MORGAN OFFSHORE WIND PROJECT: GENERATION ASSETS

Outline marine mammal mitigation protocol

Deadline ~~6~~⁵

Document Number: MRCNS-J3303-RPS-10117

Figure 1.3: UXO clearance mitigation.

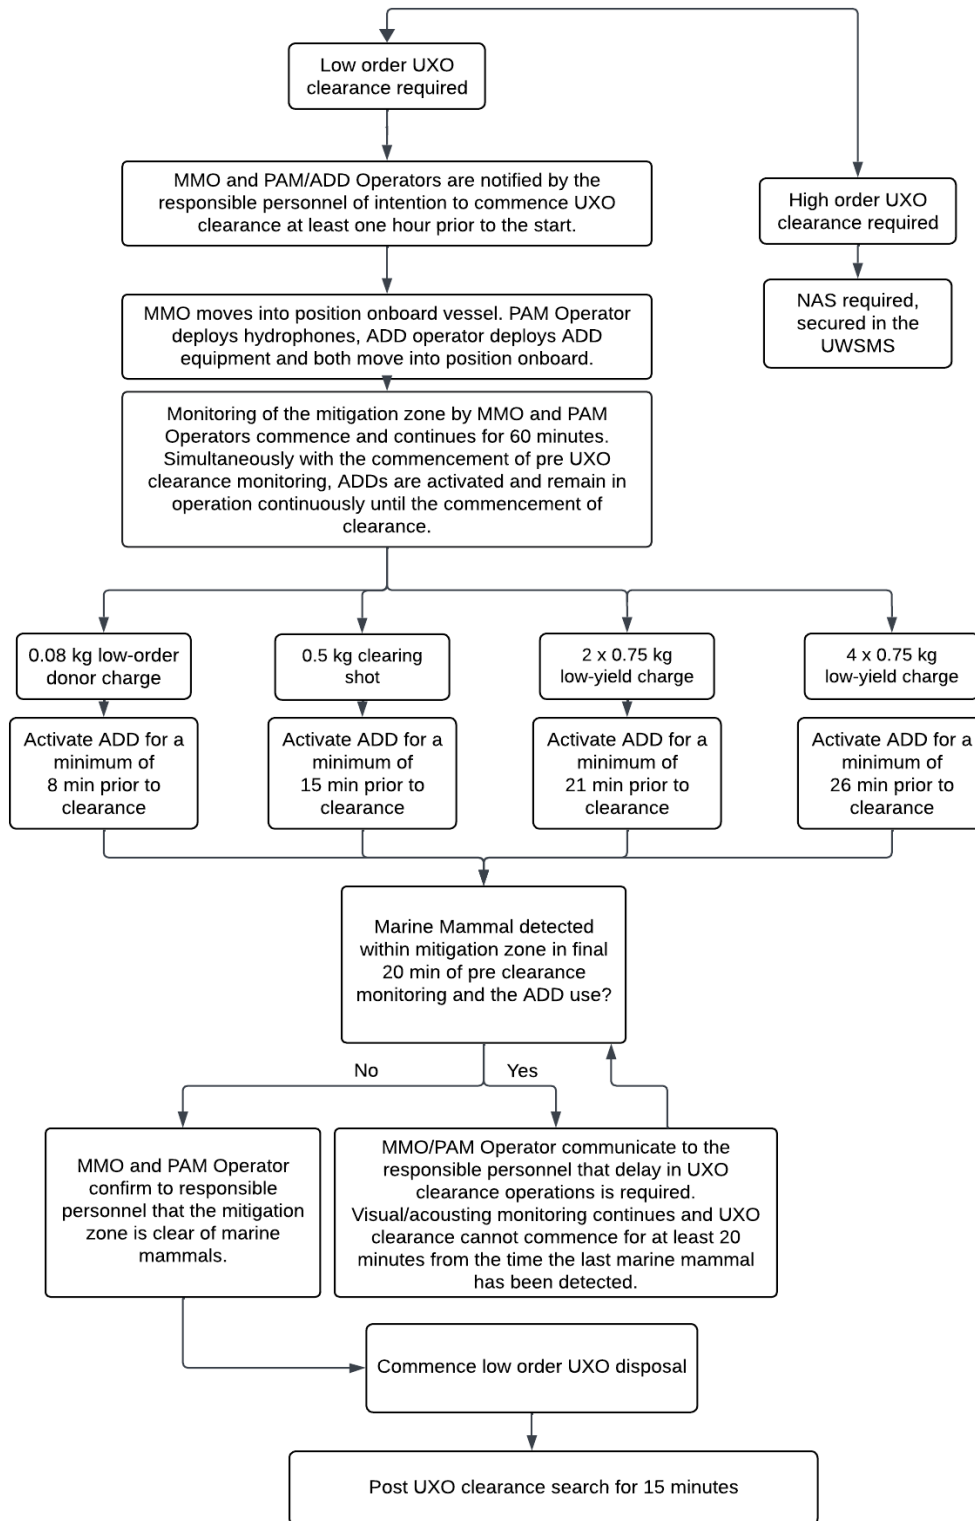
1.8.1.2 The above UXO clearance mitigation plan has been developed in line with the latest Defra position paper [Error! Bookmark not defined.](#) and JNCC mitigation guidance (JNCC, 2025). The position paper states that high order clearance should always be the last resort and that a minimum of three attempts should be made before high order is considered and this would require a separate marine licence. In addition, where high order clearance is required there is a commitment to use NAS as a secondary measure and this has been covered in the outline UWSMS.

- 1.8.2.1 Following the JNCC (2010b25) guidelines, ~~pre-detonation~~ monitoring of the minimum 1km mitigation zone prior to low order clearance should be conducted by MMOs in order to reduce the risk of marine mammals being present within this area. MMOs should be present in sufficient numbers to ensure that monitoring is not compromised by fatigue. Prior to the commencement of the ~~pre-detonation~~ clearance monitoring, an individual who holds overall responsibility for operations during UXO clearance (e.g. EOD Supervisor, see paragraph 1.6.5.1) will provide advance notice to the MMOs, PAM and ADD Operators at least one hour prior to the scheduled commencement of UXO clearance. This advance notice will allow for an adequate time period for the survey and the soft start procedure.
